HISTORIC AND DESIGN REVIEW COMMISSION

HDRC CASE NO: 2022-517
ADDRESS: 830 W COMMERCE ST
LEGAL DESCRIPTION: NCB 284 BLK 23 LOT E 14.2 OF 1, 2 & W 45.6 OF 3 ARB A2
ZONING: D, H
CITY COUNCIL DIST.: 5
DISTRICT: Cattleman Square Historic District
LANDMARK: Individual Landmark
APPLICANT: Sue Ann Pemberton/Mainstreet Architects Inc.
OWNER: Dix Densley/DGSD-830 W COMMERCE ST LLC
TYPE OF WORK: Construction of a 3-story addition and rooftop addition, exterior modifications
APPLICATION RECEIVED: September 30, 2022
60-DAY REVIEW: Not applicable due to City Council Emergency Orders
CASE MANAGER: Rachel Rettaliata

REQUEST:

1. Reconstruct the 1-story building on the east side of the structure with a second-story addition.
2. Construct a 3-story rear addition.
3. Install a new steel balcony and exterior staircase on the south (rear) elevation.

1 EAST EXTERIOR ELEVATION
SCALE: 1/8" = 1'-0"

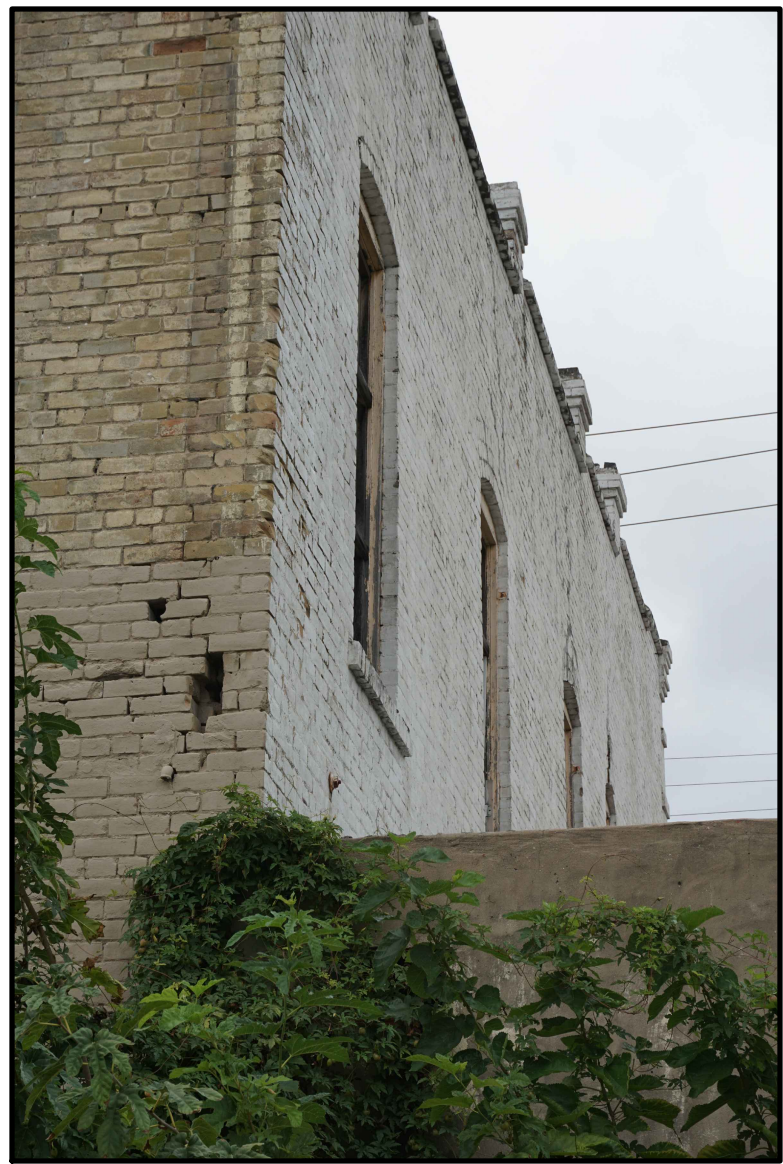
- d. EAST ADDITION: MASSING – The applicant has proposed to construct a 2-story addition to the east side of the property. The previous proposal featured a 3-story addition that featured 2 stories that were visible above the 1-story structure and was significantly setback from the front façade. The applicant has modified the proposal to feature a 2-story addition on the east side of the front façade that will replace the existing 1-story structure and will be flush with the front façade of the historic structure. The proposed 2-story portion of the addition will match the third-floor plate height of the 2-story structure but will feature a parapet cap that is taller than the historic structure. The applicant has proposed to construct a 3-story rear addition that will be visible behind the newly proposed 2-story addition. According to Guideline 2.A.iv for Additions, additions should be designed to be subordinate to the principal façade of the original structure in terms of their scale and mass. Staff finds that without the significant setback from the front façade, the addition no longer appears subordinate to the historic structure. Staff finds that the applicant should reduce the overall massing of the proposed addition or site the addition significantly behind the front façade wall plane.

- g. ADDITIONS: WINDOW REMOVAL – The applicant has proposed to install a 2-story east addition and 3-story rear addition. The proposed east and rear additions will require the removal of five (5) existing windows on the east elevation of the historic 2-story structure. Staff finds that the applicant should submit a demolition and architectural salvage plan detailing the proposal for material and window removal to staff for review.

- iii. That the applicant reduces the overall massing of the proposed east side addition or sites the addition significantly behind the front façade wall plane based on finding d. The applicant is required to submit updated site plans and elevation drawings to staff for review and approval prior to the issuance of a Certificate of Appropriateness.

- vi. That the applicant submits a demolition and architectural salvage plan detailing the proposal for material and window removal based on finding g.

1 WEST EXTERIOR ELEVATION
SCALE: 1/8" = 1'-0"

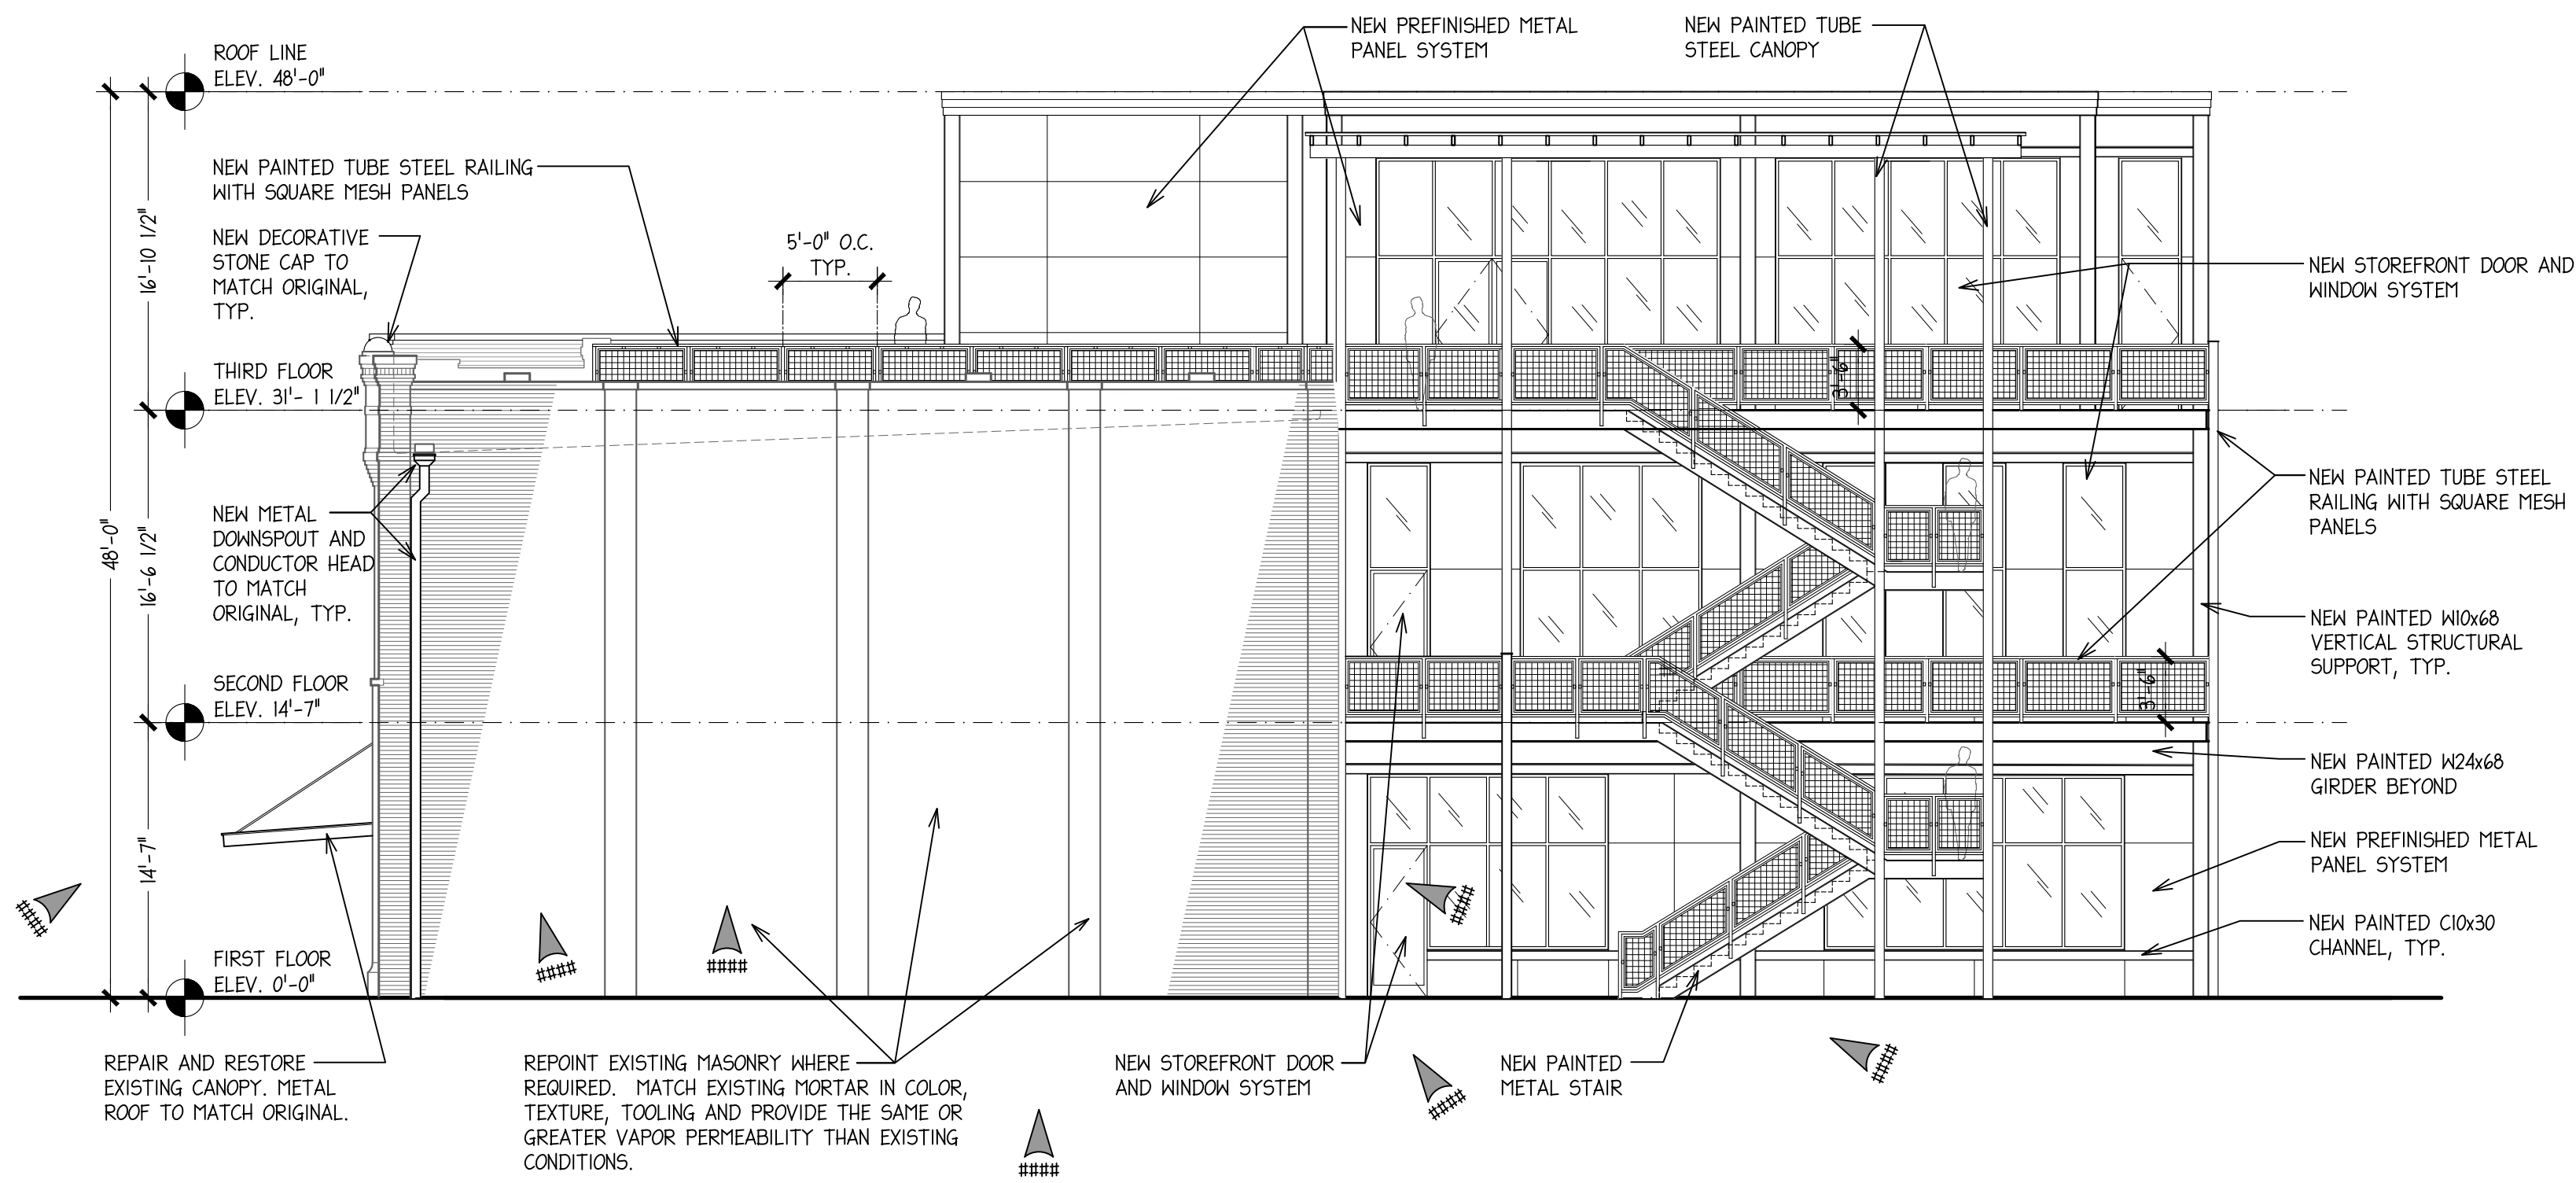
- h. ADDITIONS: NEW WINDOW SIZE AND PROPORTION – The applicant has proposed to install storefront window systems on the front façade, south (rear), and west elevations of the east and rear additions. Staff's

- k. ADDITIONS: ARCHITECTURAL DETAILS – The applicant has proposed to construct east and rear additions that are simplified in style. Guideline 4.A.ii for Additions recommends that applicants incorporate architectural details that are in keeping with the architectural style of the original structure. Details should be simple in design and compliment the character of the original structure. Architectural details that are more ornate or elaborate than those found on the original structure should not be used to avoid drawing undue attention to the addition. Staff finds the proposal for the second and third stories of the east and rear additions consistent with the Guidelines but finds that the first story of the east addition should feature architectural details in keeping with the existing 1-story front façade as previously proposed.

STAIR S2 - SECTION LOOKING EAST
SCALE: 1/2" = 1'-0"

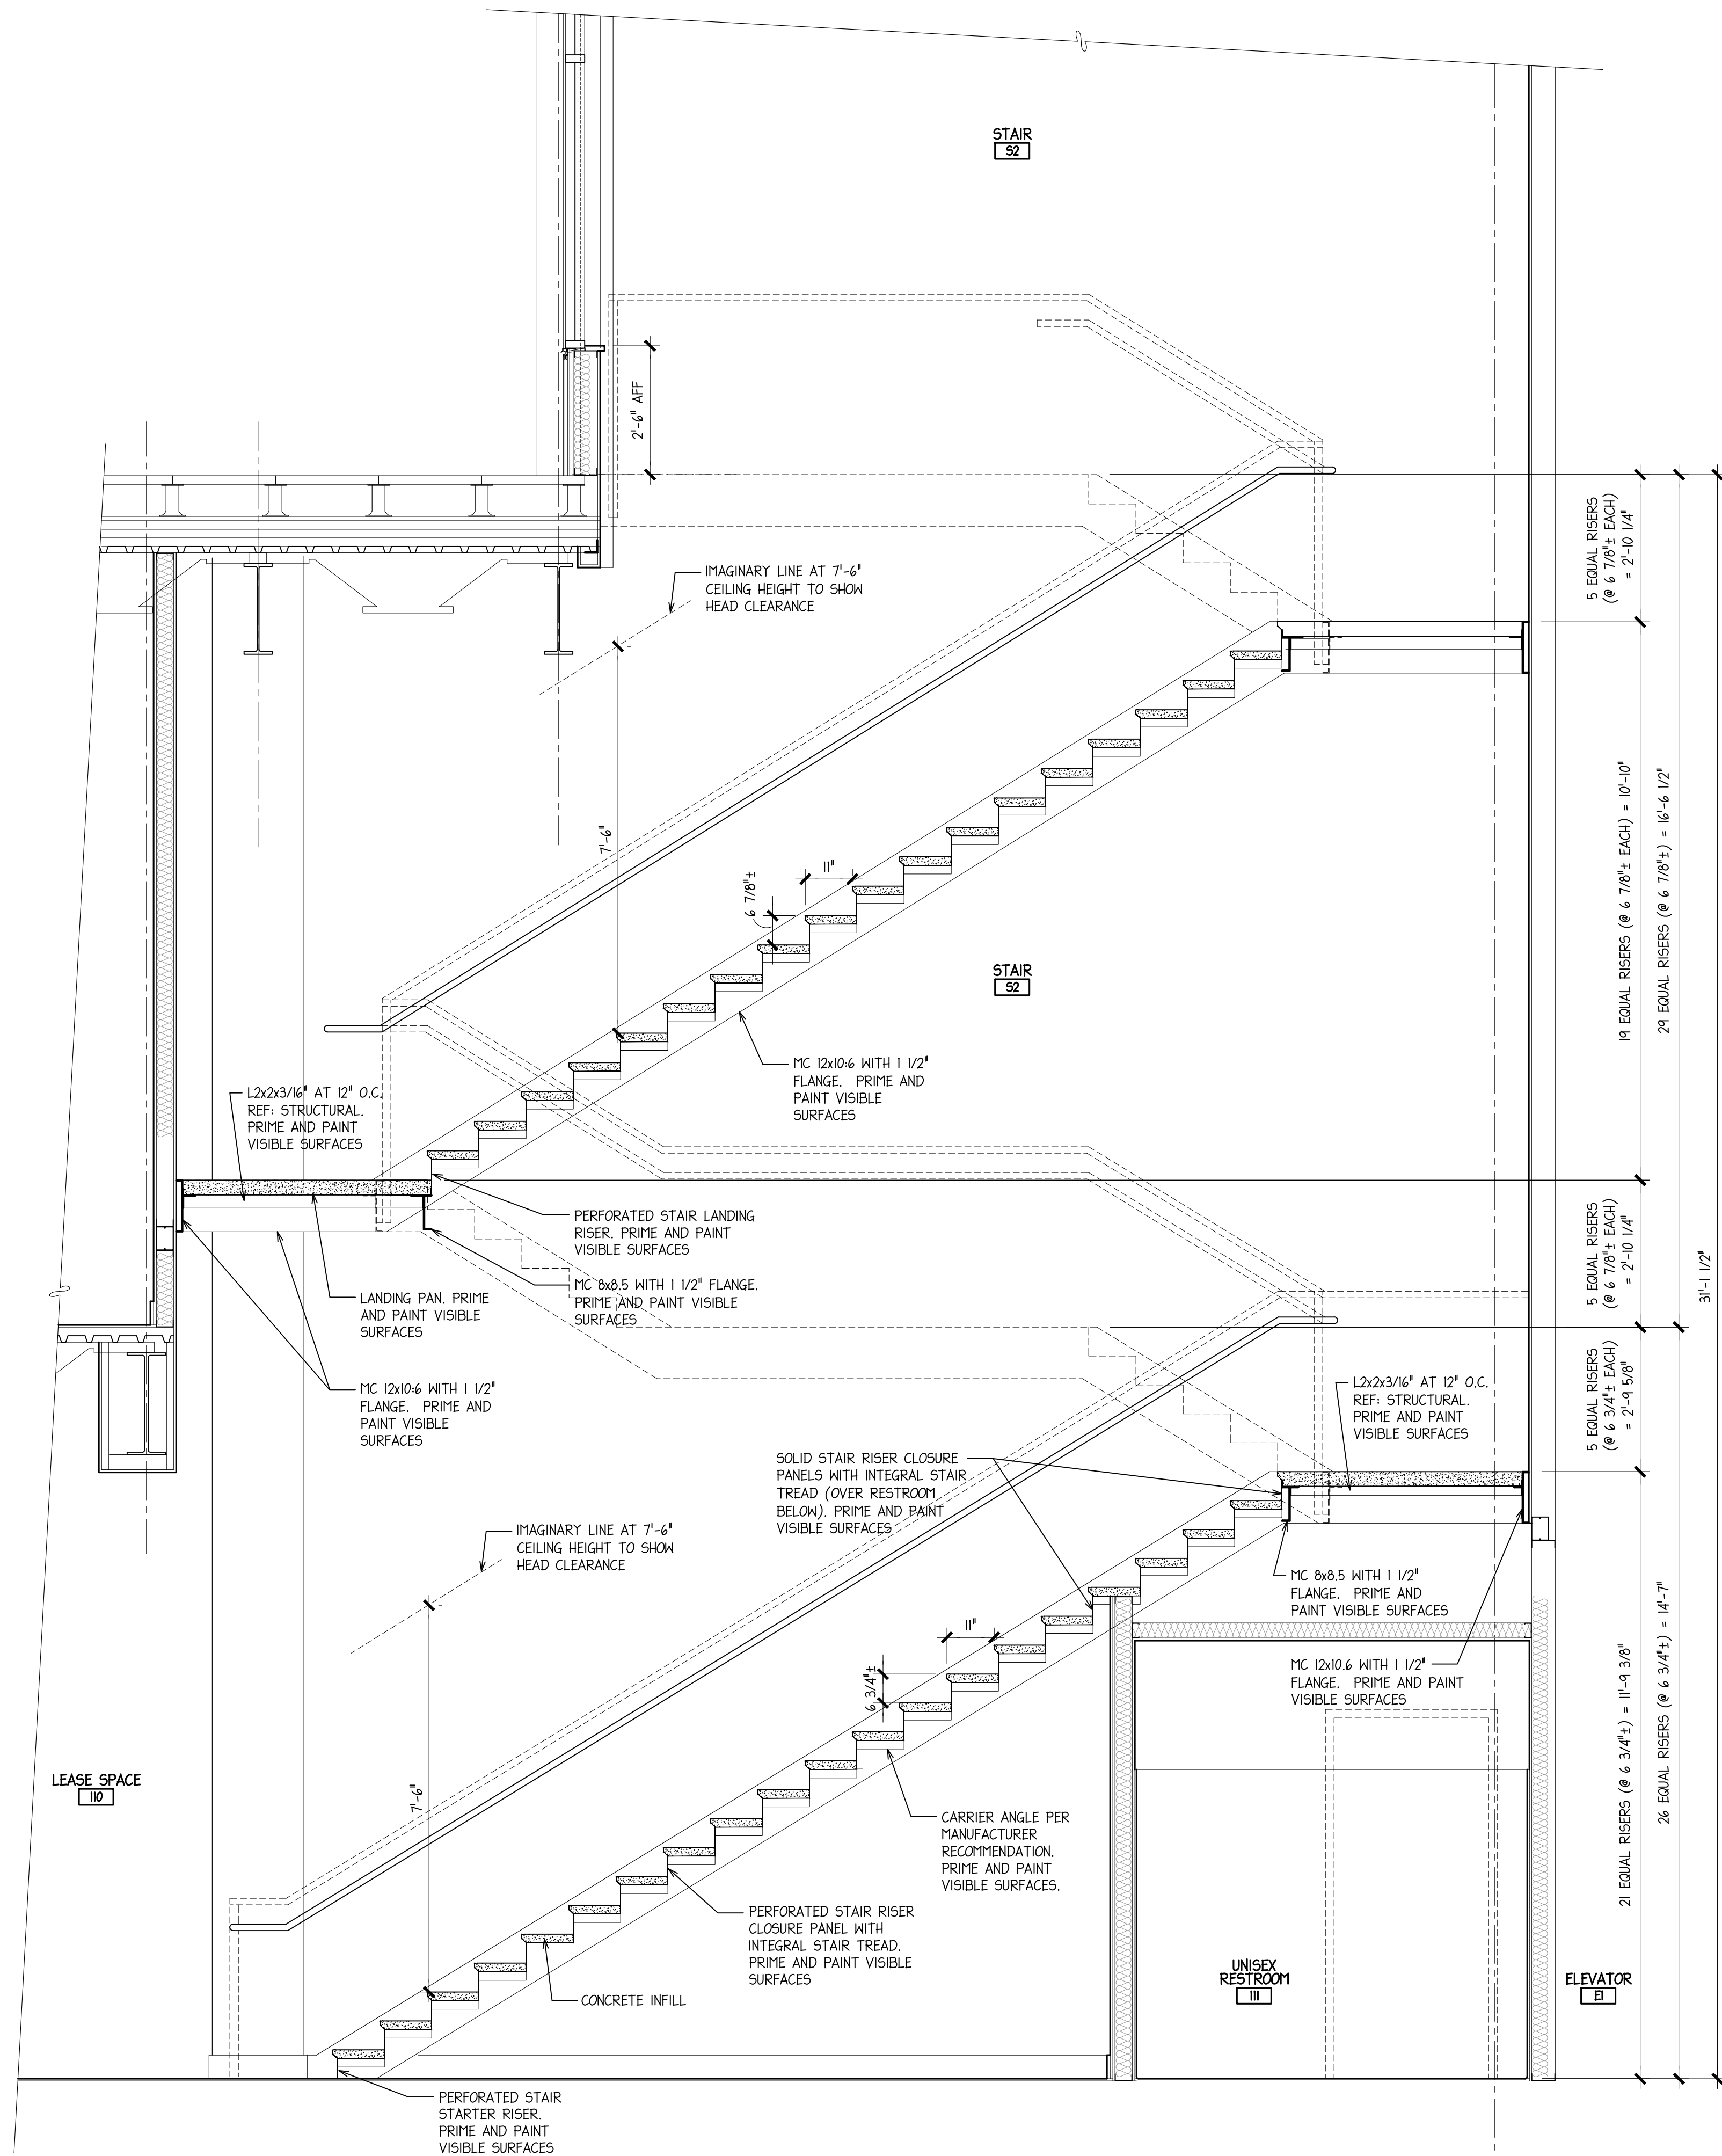
- m. STEEL BALCONY AND EXTERIOR STAIR INSTALLATION – The applicant has proposed to install steel balconies and an exterior staircase on the south (rear) elevation. The applicant has expressed that the structure

previously featured a rear balcony on the south elevation. According to Guideline 7.B.iv for Exterior Maintenance and Alterations, replacement elements, such as stairs, should be designed to be simple so as to not detract from the historic character of the building. Do not add new elements and details that create a false historic appearance. Staff finds the materials and design appropriate for the commercial structure.
